Appendix J – Road Safety Audit Designers Response

Title: 23161 TN13 Road Safety Audit designers' response – 1st Issue

1.2 The purpose of this report is to provide a Designer's Response (DR) to the Stage 1 Road Safety Audit (RSA) carried out by 'J Bartlett Consulting Ltd' in May 2025. This Stage 1 RSA related to the access proposals associated with the two development sites.

PROJECT REF: 23161	STATUS: N/A
DRAWING No: 021	REV: P1

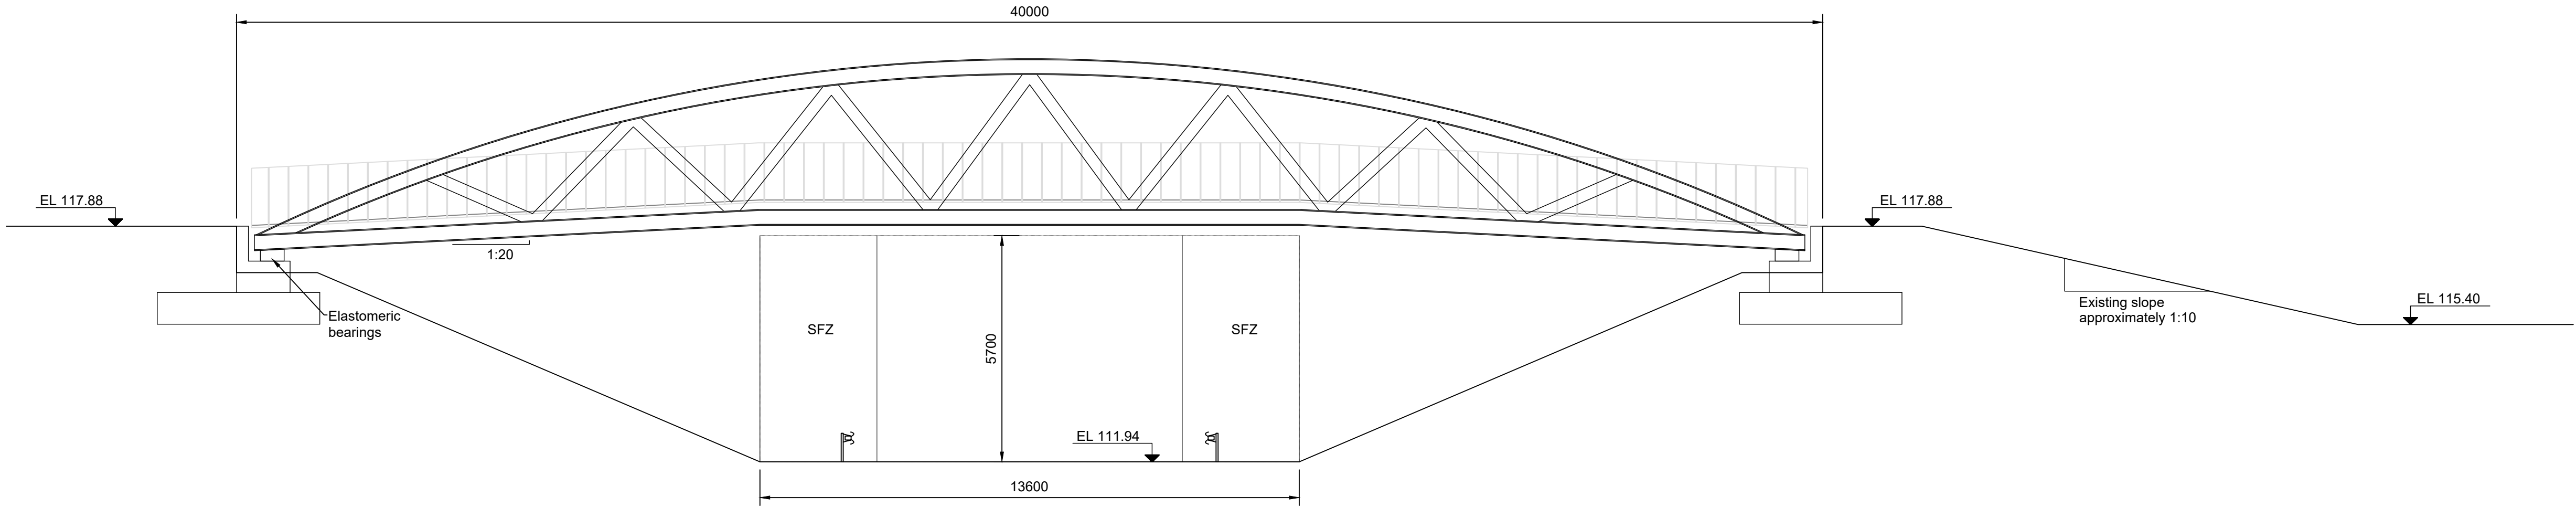
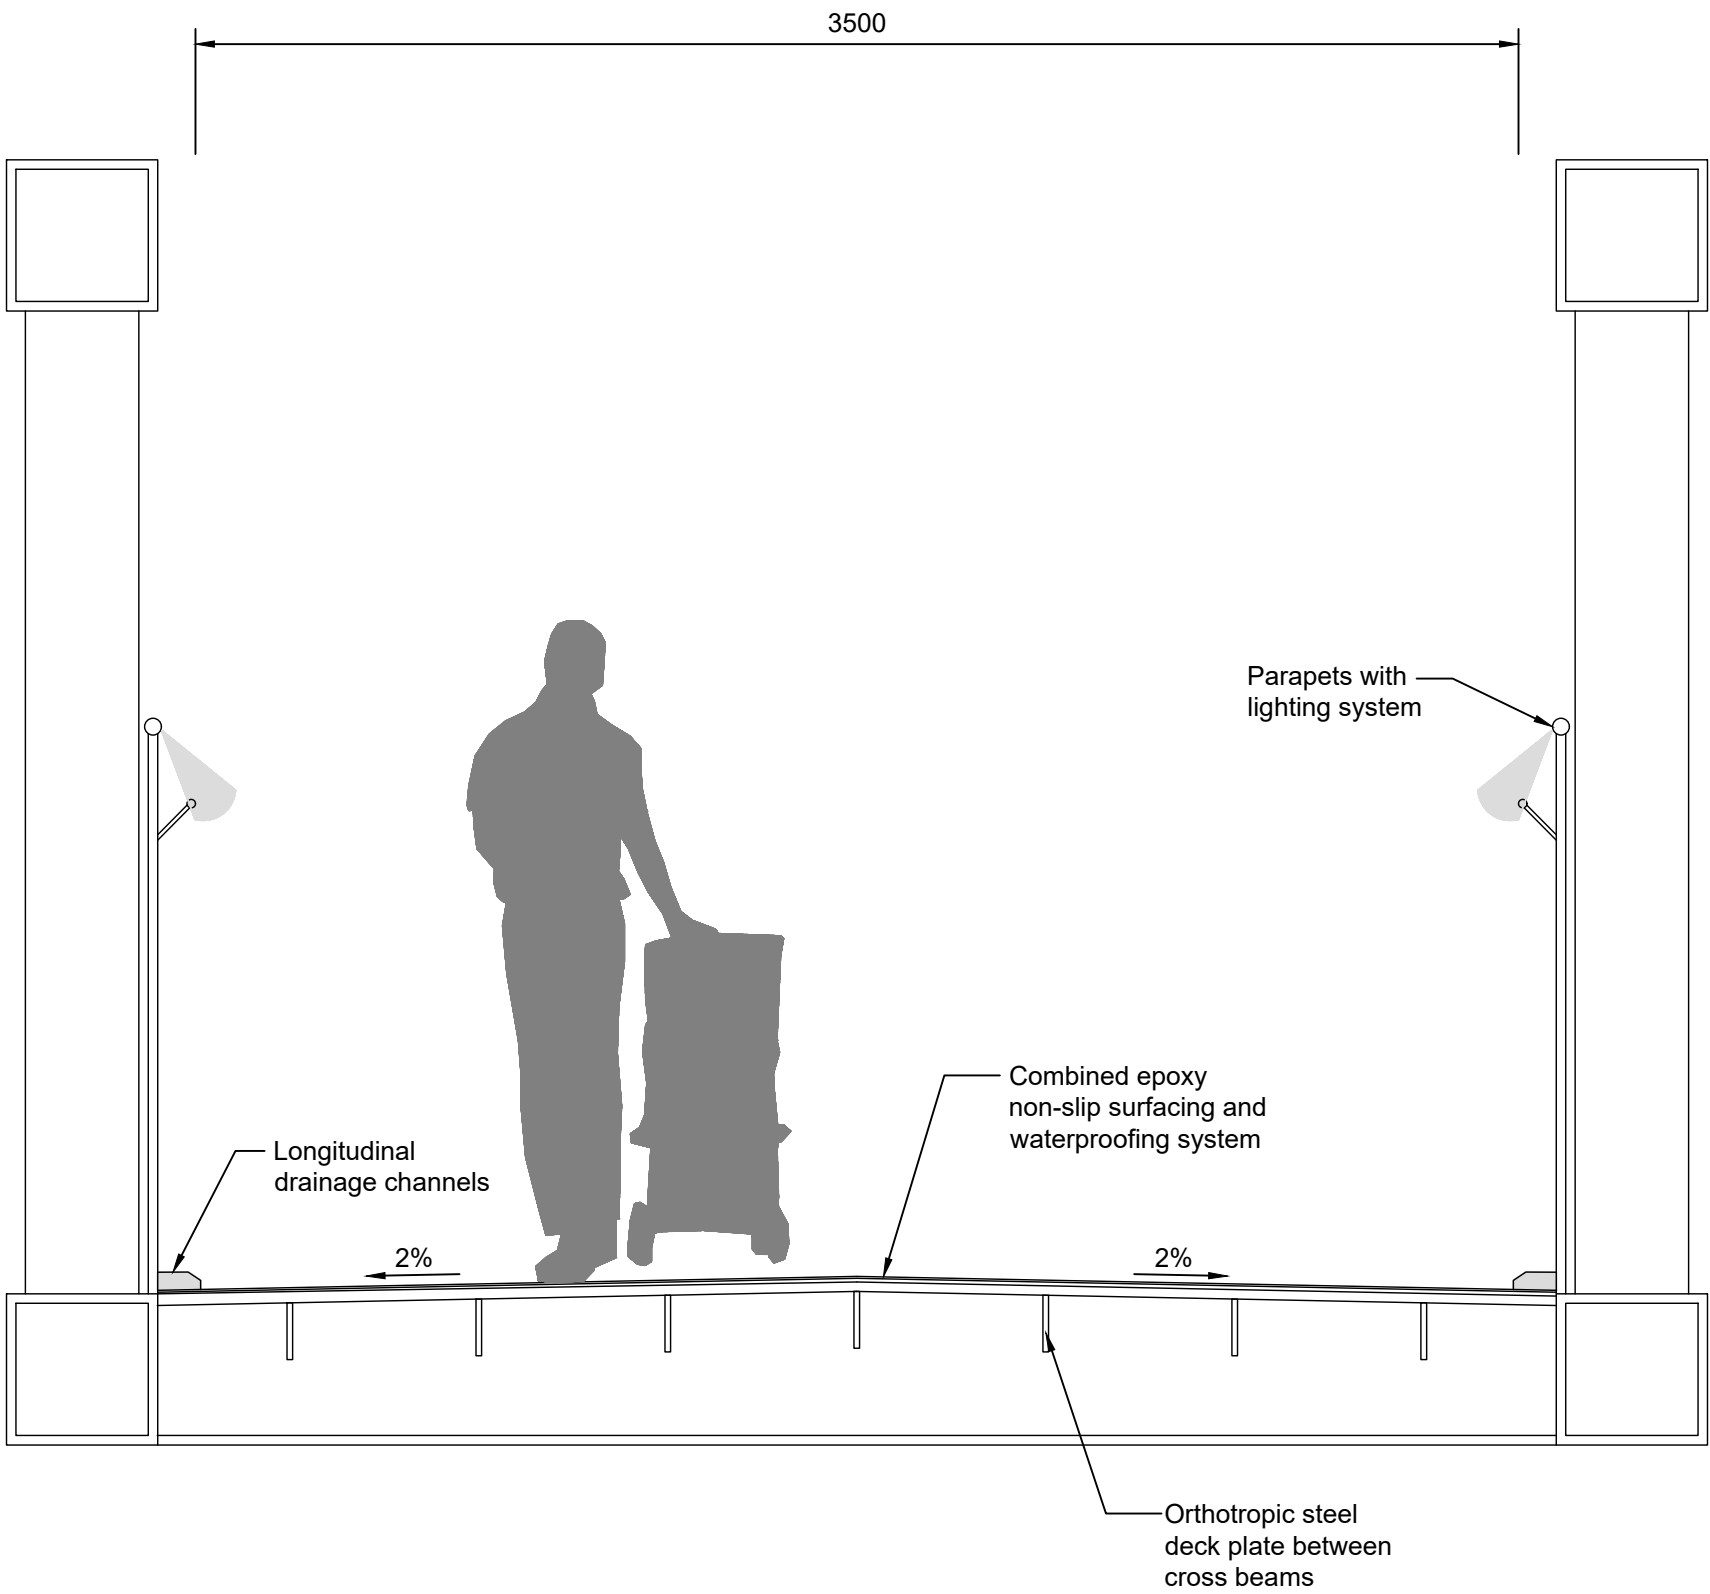
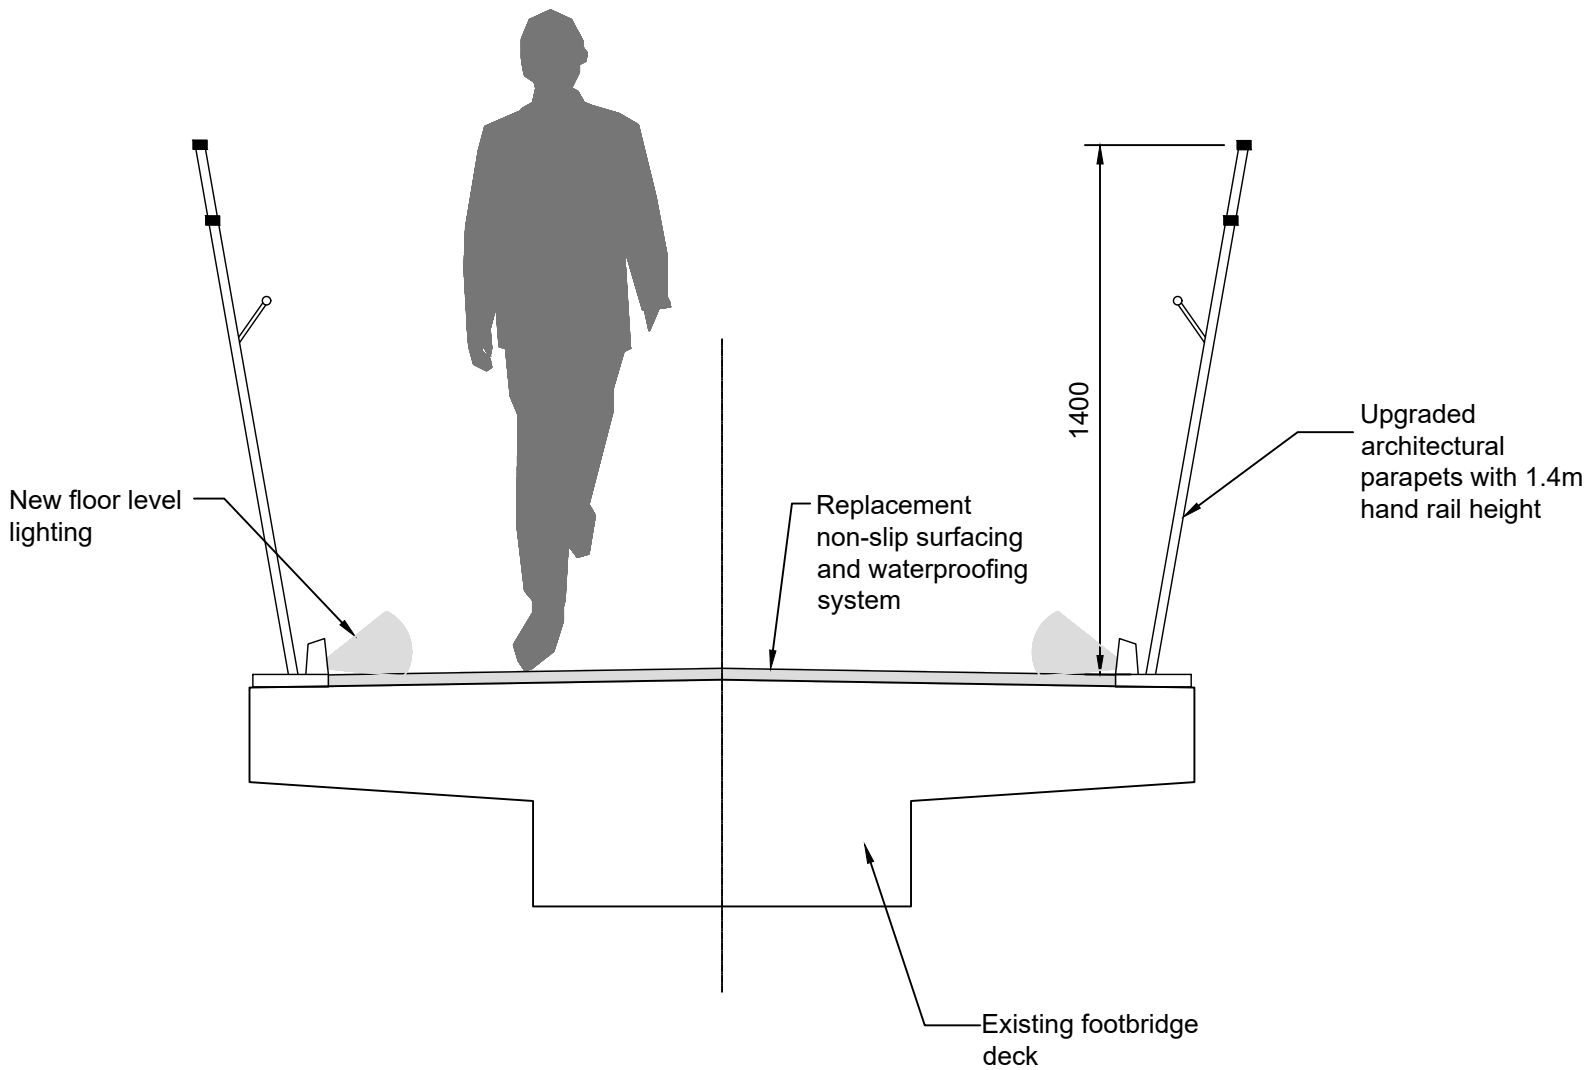
"One of the drawing numbers is illogical and it has been assumed that this is a drafting mistake and will be rectified as the scheme progresses."

- 2.2 This refers to the southern bridge crossing plan drawing, which should be referenced as 021 (P1). This drawing has been reviewed as part of the audit with no design issues identified. Notwithstanding this, labelling will be corrected in the final submission pack.
